DE ANZA COLLEGE FACILITIES MASTER PLAN

FINAL ENVIRONMENTAL IMPACT REPORT

SCH# 2000112005

**De Anza College
Facilities Master Plan
Final EIR Addendum**

FIGURE 3.0-3

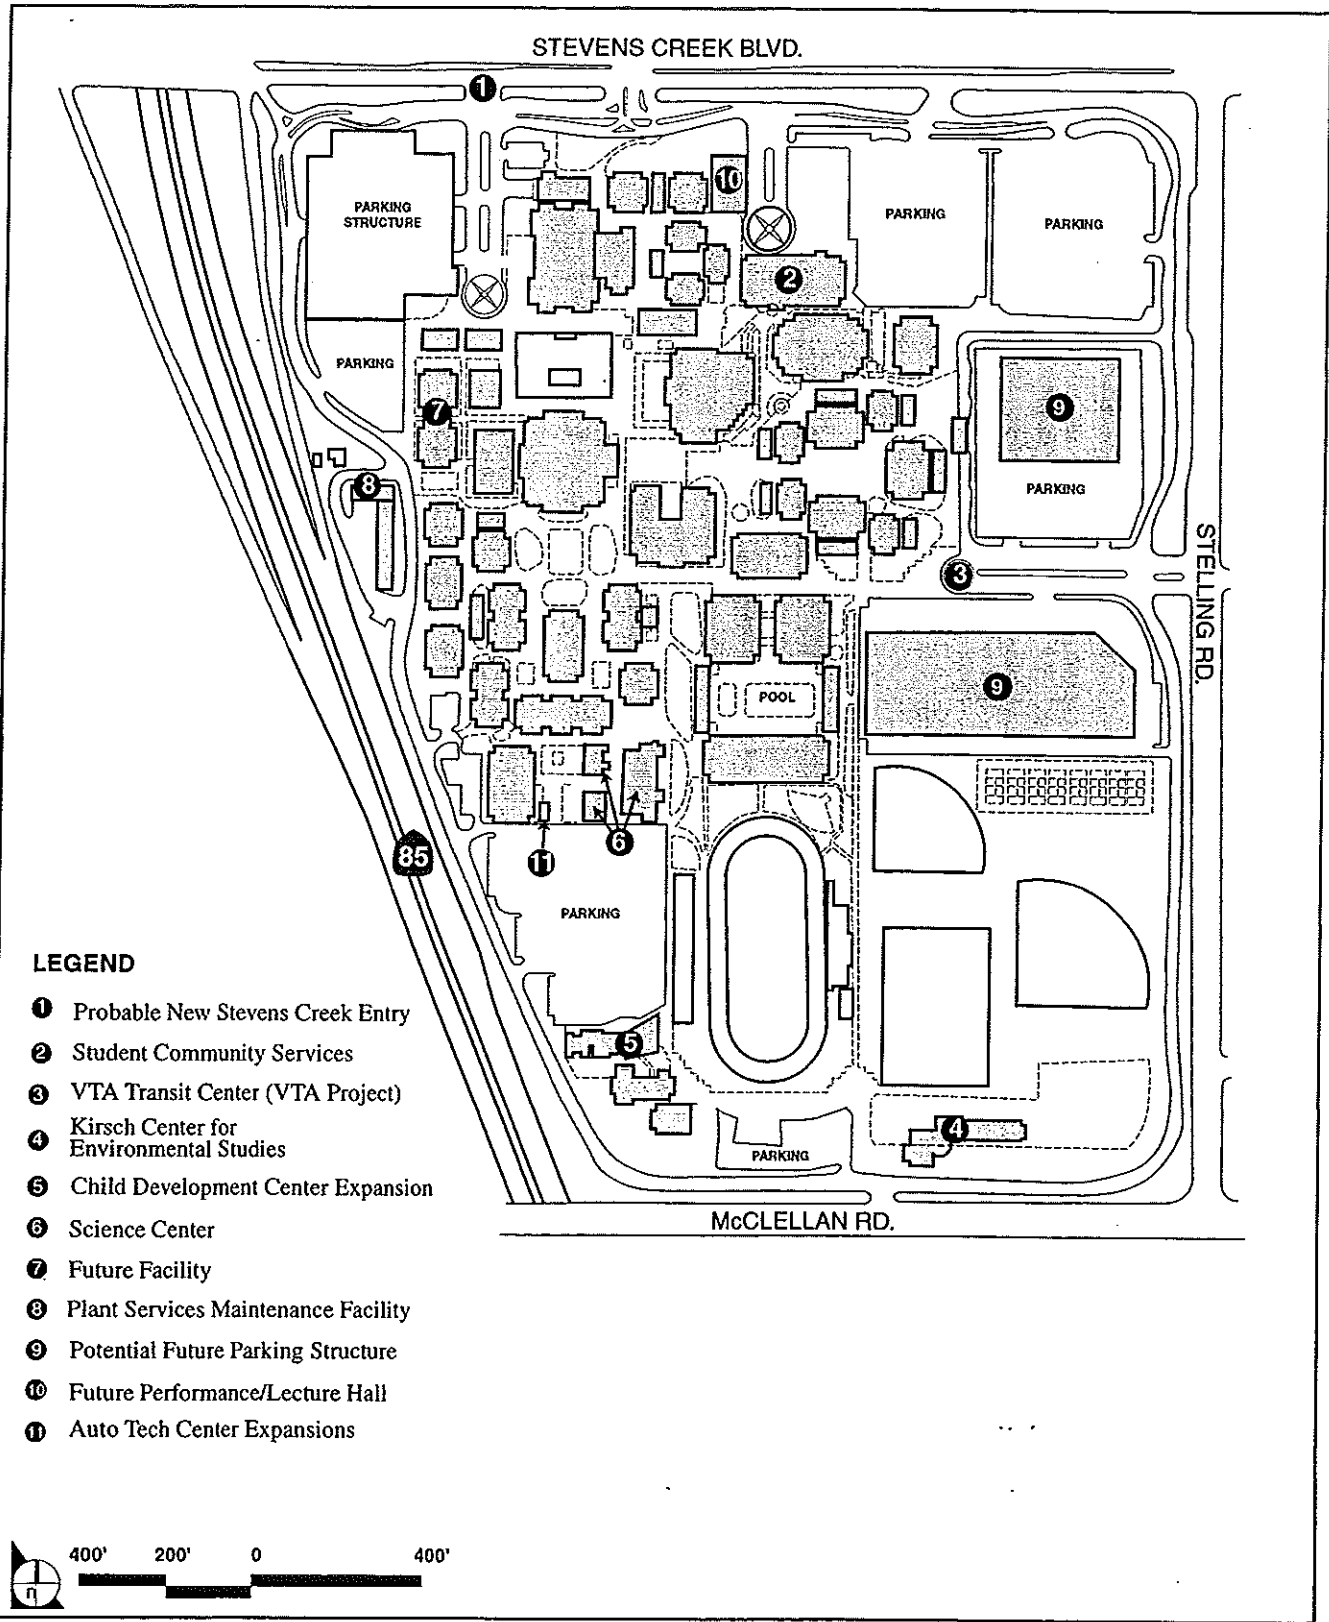
The project site access at the northwest corner of the college campus is shown differently in Figure 3.0-2 (Existing College Campus) and Figure 3.0-3 (Proposed College Campus). We believe the access shown in Figure 3.0-3 is currently existing at the project site. If this is true, please correct Figure 3.0-2.

Page 3.0-11, Figure 3.0-3 (Staff-initiated):

- B-8. The two figures are correct. As discussed on p. 3.0-17 of the Draft EIR, construction of the Plant Services/Warehouse building would include the realignment of the campus loop road on the west side of campus. The northwest section of the loop road would be further extended to the west.
